PLANNING AND ZONING COMMISSION REGULAR MEETING AGENDA

WEDNESDAY, MARCH 14, 2018

| 3. Consideration, discussion, and possible action on a Final Plat for Manor Commons SE Commercial Phase 1, two (2) lots on 22.62 acres more or less, located near the intersection of US Hwy 290 and FM 973/Loop 212. Applicant: Matt Mitchell, ALM Engineering. Owner: Barth Timmermann | Scott Dunlop Planning Coordinator |

4. Consideration, discussion, and possible action on a Final Plat for Village at Manor Commons Phase 1, ninety-three (93) single family lots on 19.29 acres more or less, located near the intersection of Old Hwy 20 and Bella Parkway. Applicant: Matt Mitchell, ALM Engineering. Owner: Barth Timmermann. Scott Dunlop
Planning Coordinator

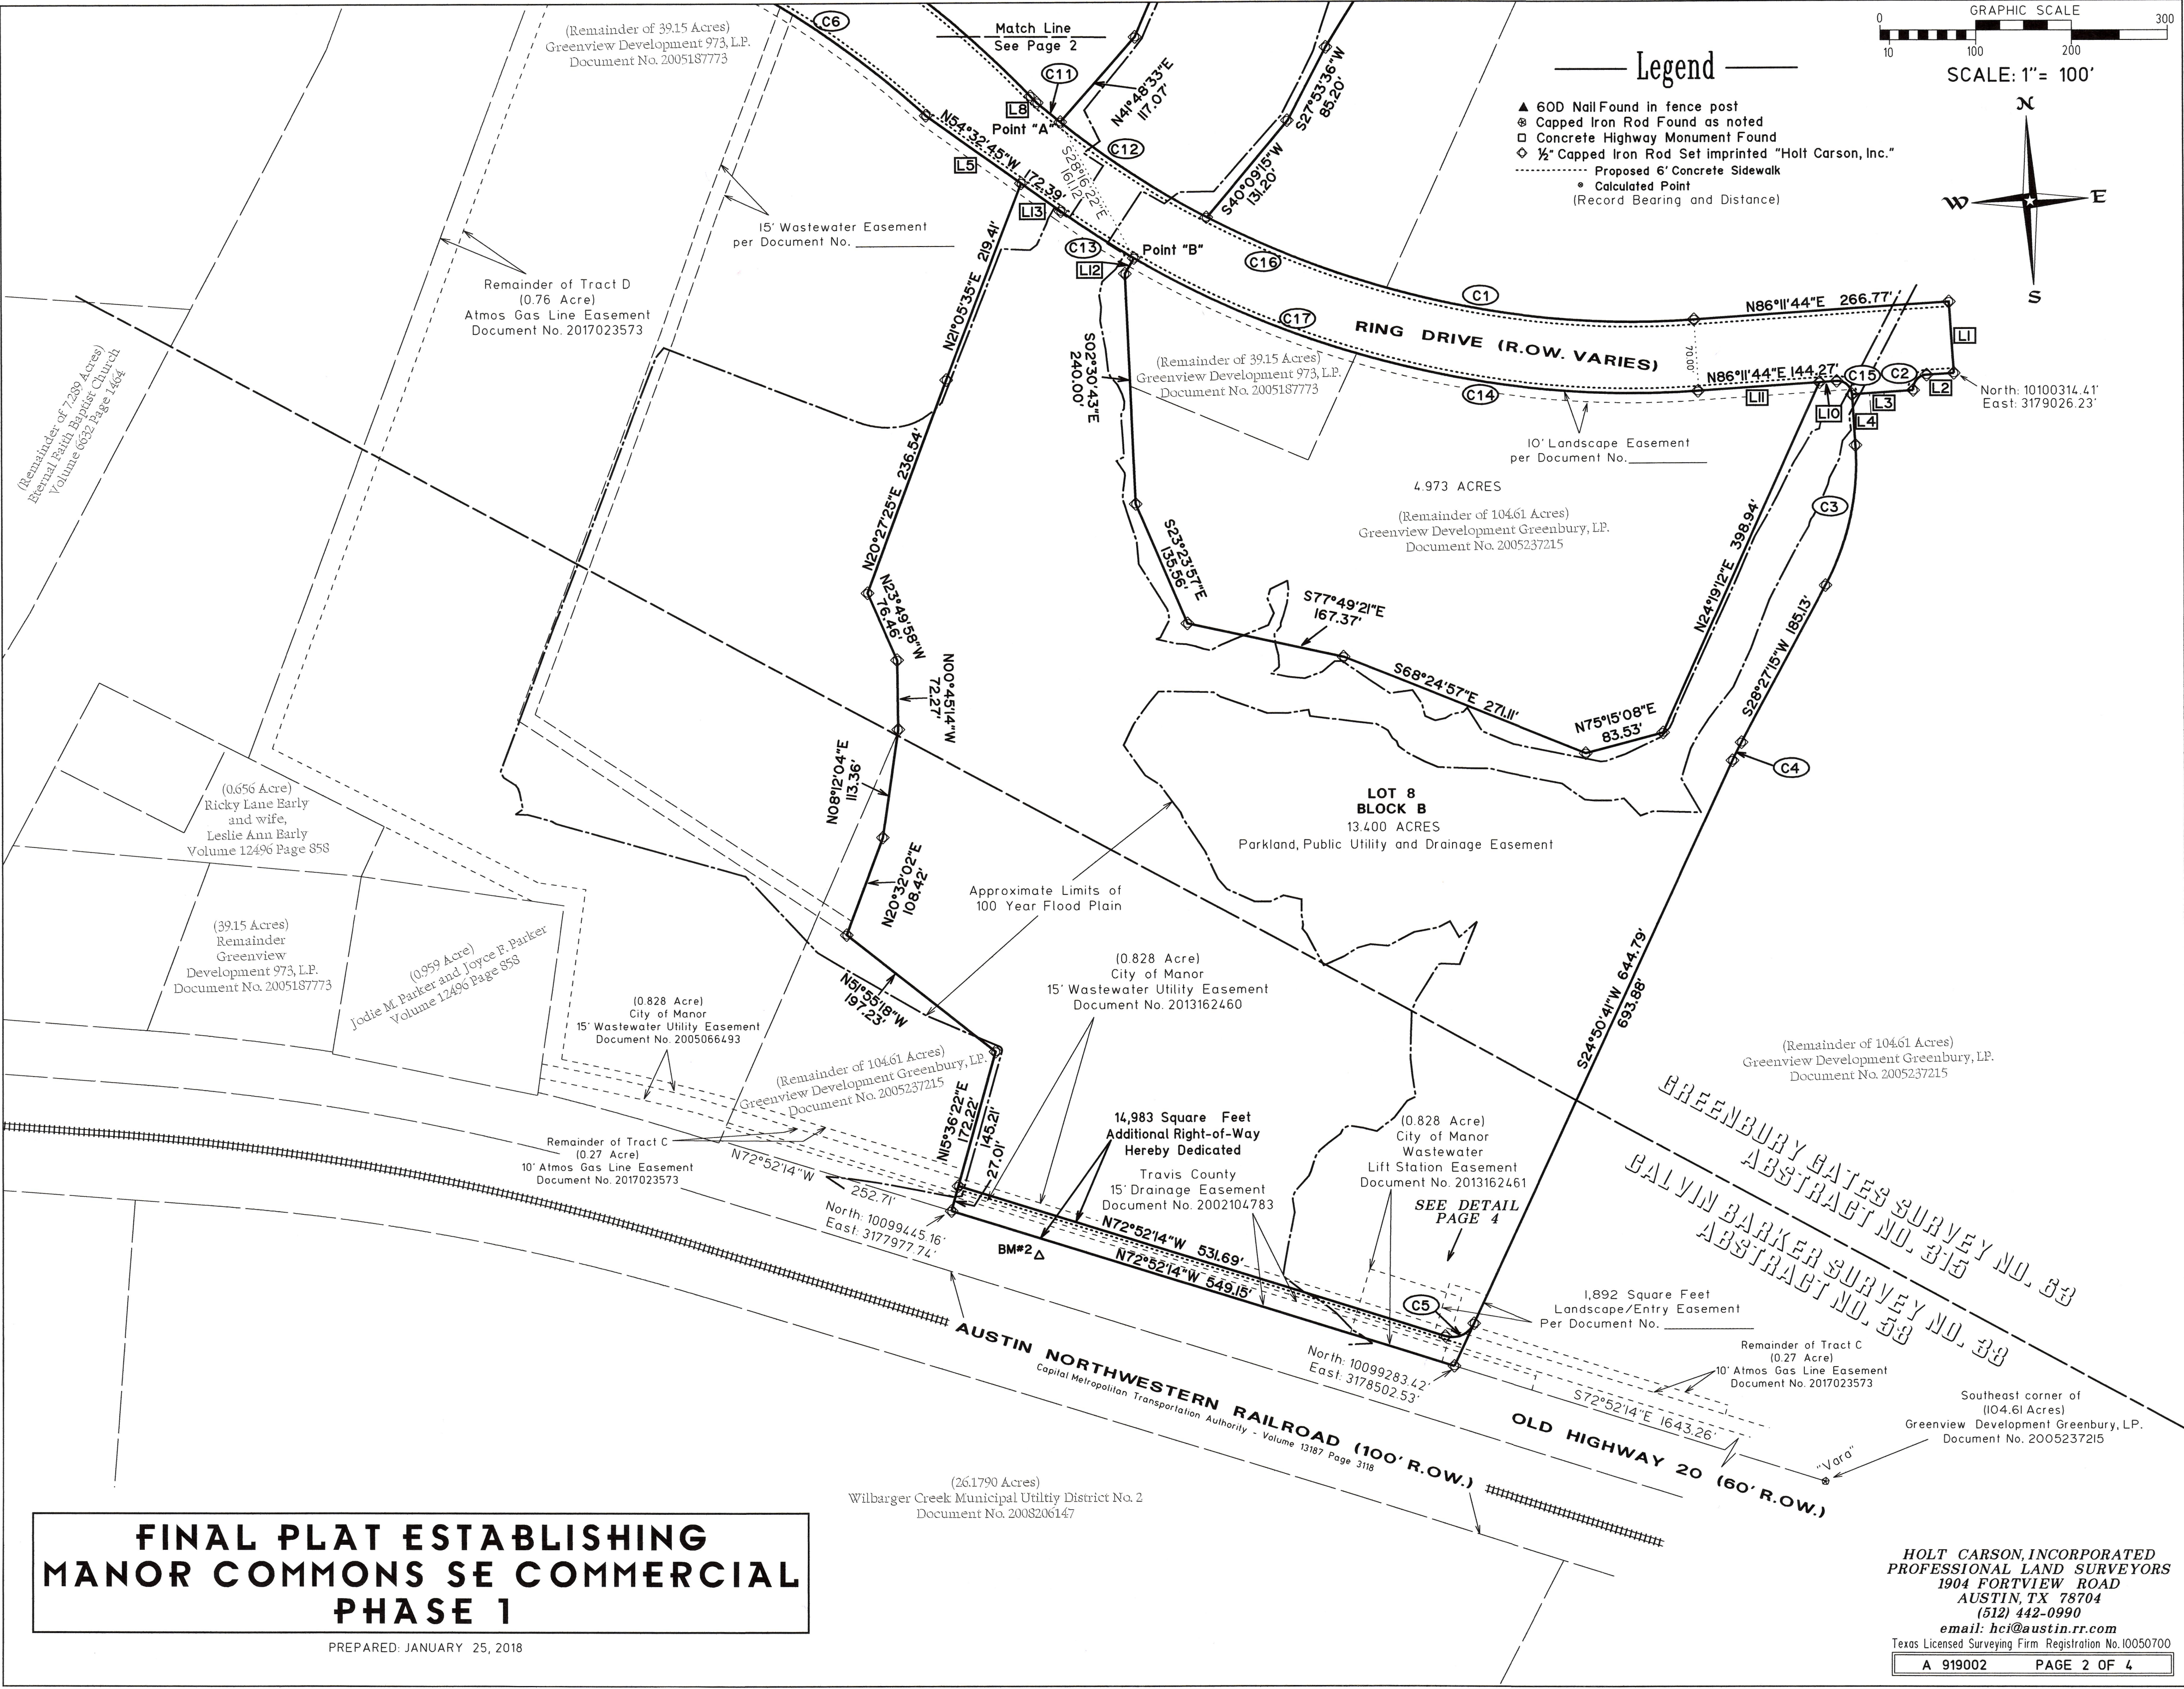
1. The new City Secretary is Lluvia Tijerina.
2. A description should be added for the railroad right-of-way that is shown on the plat. (Owner, document number, etc.)

3. It is hard to distinguish between the easements shown on the south portion of the development on Sheet 2 of plat.
4. There is a wastewater easement shown on the plat without a document number.

5. Lot 8 Block B and Lot 7 Block A are listed as a Park and Drainage Easements. Verify that the classification is correct.
6. Section 24(c)(3)(i) of Subdivision Ordinance 263B requires that true bearings and distances to the nearest established street lines, official monuments, or existing subdivision corner which shall be accurately described on the plat and rotated to the state plane coordinate system. Using said system, X and Y coordinates shall be identified for four (4) property corners.

8. On Sheet 1 there is a 10' PUE shown that appears to be shown in the same spot as the Atmos Gas Line Easement.
9. Section 24(c)(4)(viii) of Subdivision Ordinance 263B requires that the proposed locations of sidewalks for each street be shown as a dotted line inside the proposed right-of-way.

13. Matchlines should be added to Sheets 1 and 2.
14. The following note should be added to the plat: This subdivision is located within the City Limits of the City of Manor.

15. A note should be added as to will own and maintain the proposed Park and Drainage Lots.
16. General note 1 servint should be corrected to say serving.

ADDED RAILROAD RIGHT-OF-WAY DEED REFERENCE INFORMATION

ADDED DETAIL AREA ON PAGE 4

ADDED FOURTH COORDINATE PAIR AT SOUTHEAST TERMINUS OF RING ROAD

ADDED GRAPHIC FOR PROPOSED SIDEWALK

RESPONSE: Note has been added.

RESPONSE: See the note on page 4 of the plat provided.

SHEET 1 OF 2

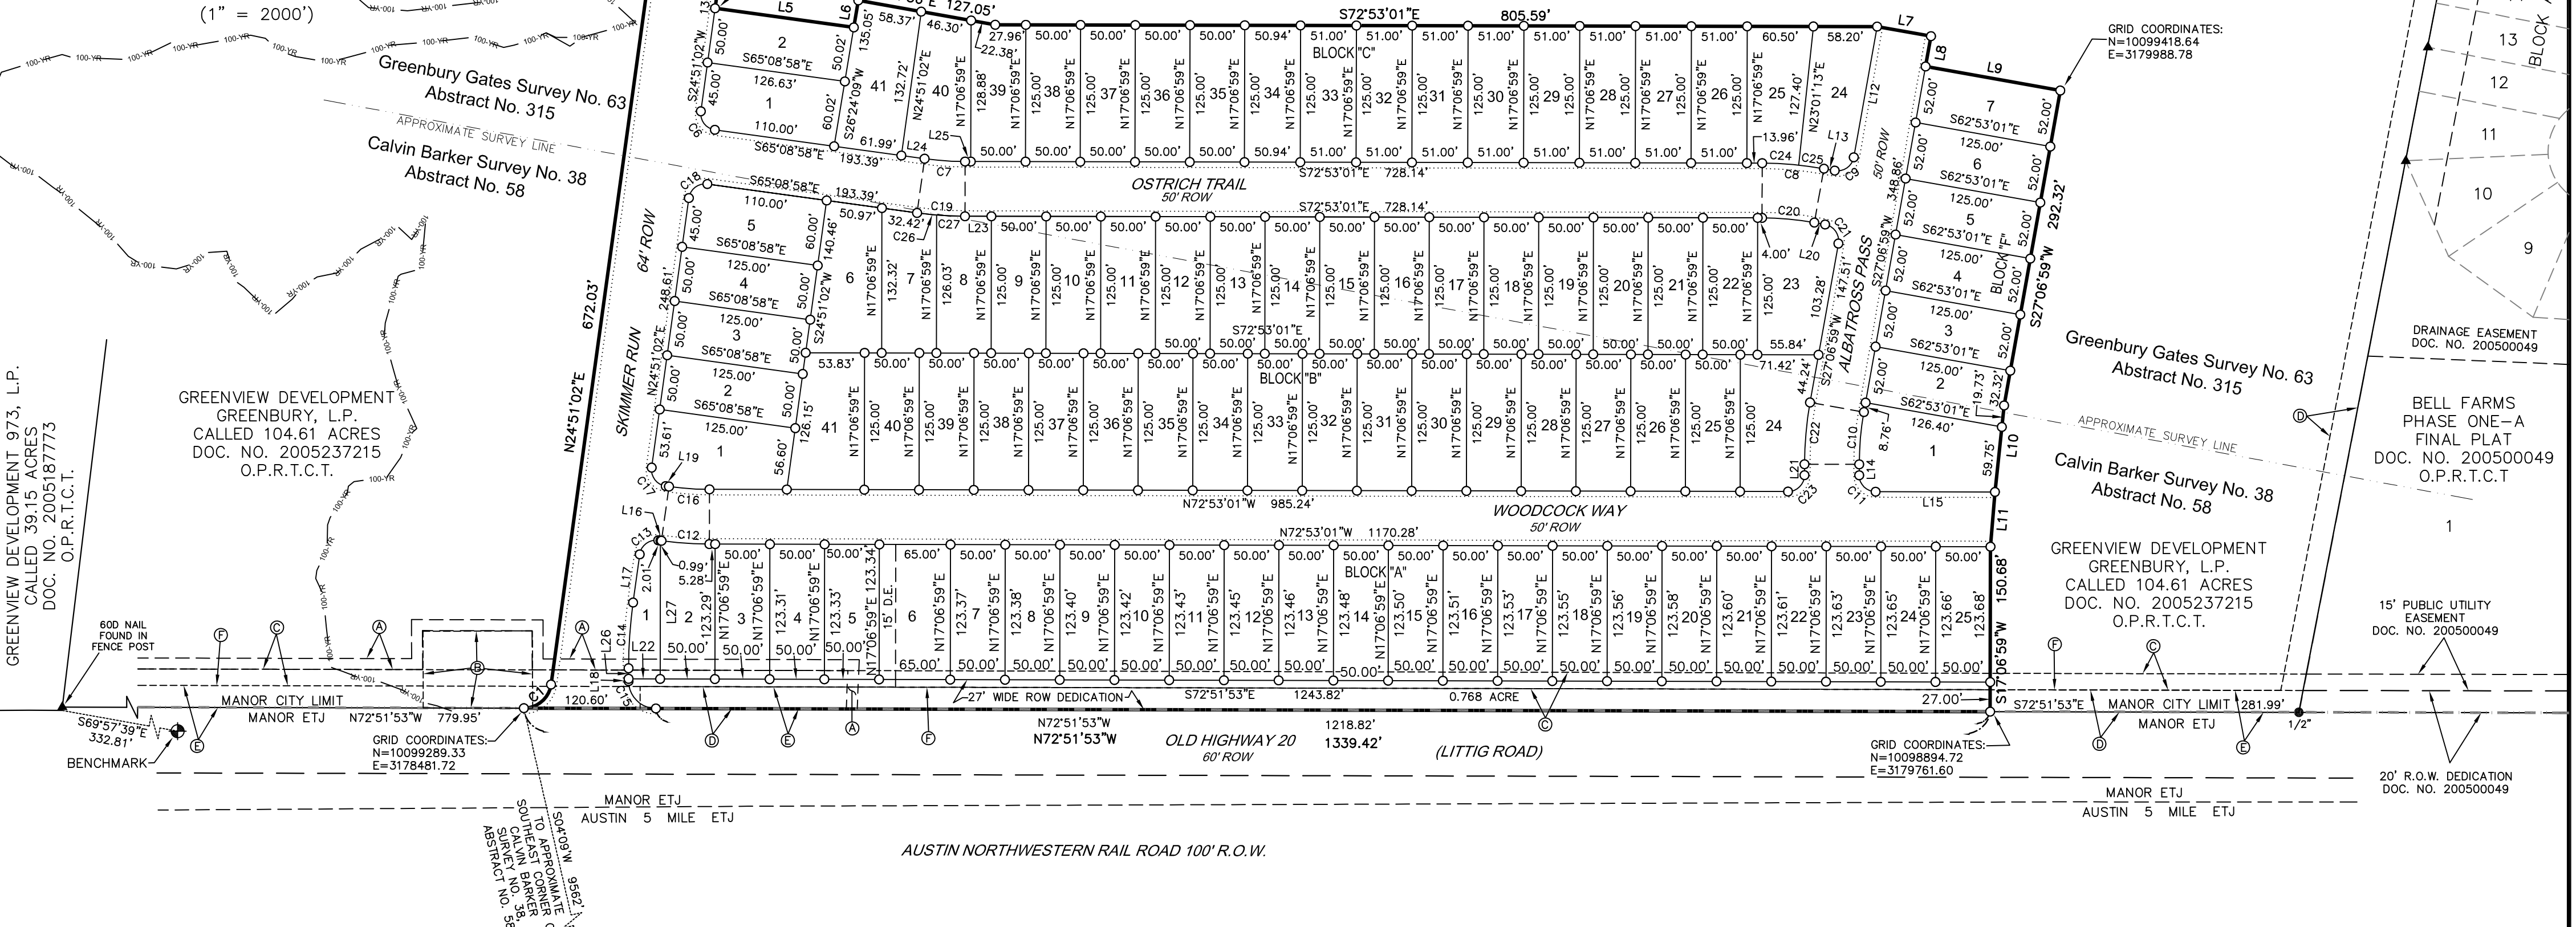
1. Note #7 should be revised. The City does not want to maintain any lots or ponds. These should be maintained by an HOA.
2. Note #12 refers to Bell Farms not Manor Village.

3. The notes on the plat should be the notes that were listed on the approved Preliminary Plat.
4. The right-of-way dedication for Old Highway 20 should be 27' not 20' based on the current City of Manor Thoroughfare Plan.

6. Verify that the floodplain note is correct. A LOMR has been approved for this area.
7. Note that if the construction of all improvements needed to serve the subdivision is not completed prior to the filing of the plat for recordation then the developer must provide financial assurance for the completion of the remainder of those improvements in accordance with the Ordinance.

1. See notes on #3
2. REMOVE NOTE #12.
3. Use notes below.
